V2500-A5/D5 SERIES PROPULSION SYSTEM SERVICE BULLETIN

This document transmits Revision 2 to Service Bulletin EV2500-72-0361 and the Initial Issue of the Supplement

V2500-ENG-72-0361

ENGINE – HP TURBINE ROTOR ASSEMBLY – INTRODUCE NEW FIRST STAGE TURBINE BLADES WITH
BLADE ROOT ATTACHMENT COATING

LOCATION OF THE STAGE 1 HPT BLADE
Figure 1

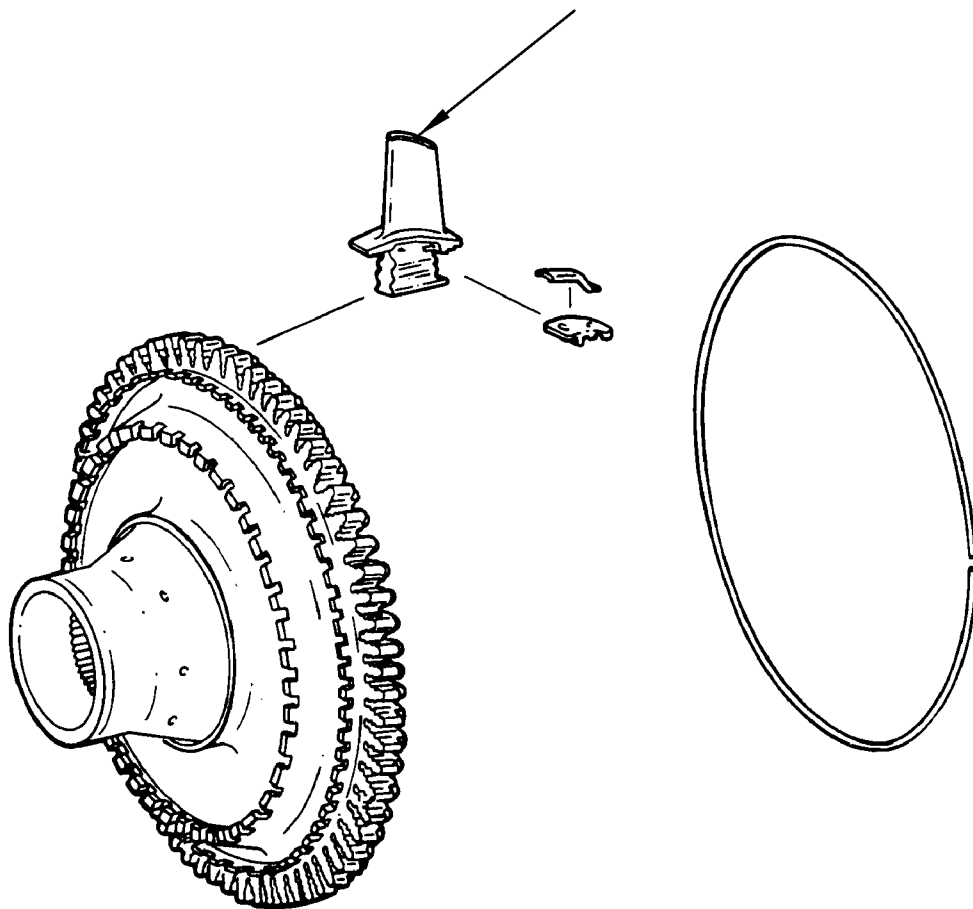
Replace the Stage 1 HPT Blades with new Blades that have had PWA 70 in addition to PWA 275 coating on the Blade Root Attachment.

REPLACE THE STAGE 1
HPT BLADE 2A9101 WITH
NEW STAGE 1 HPT BLADE 2A9201

- (1) Replace the Stage 1 HPT Blades (64 off) by the approved procedure given in Reference (8), Chapter/Section 72-45-10, Assembly-01 and Figure 1. for V2522-A5, V2524-A5, V2527-A5, V2527E-A5, V2527M-A5, V2530-A5 and V2533-A5 Engines.
- (2) Replace the Stage 1 HPT Blades (64 off) by the approved procedure given in Reference (9), Chapter/Section 72-45-10, Assembly-01 and Figure 1 for V2525-D5 and V2528-D5 Engines.
- (3) Recording Instructions
 - (a) A record of accomplishment is required.
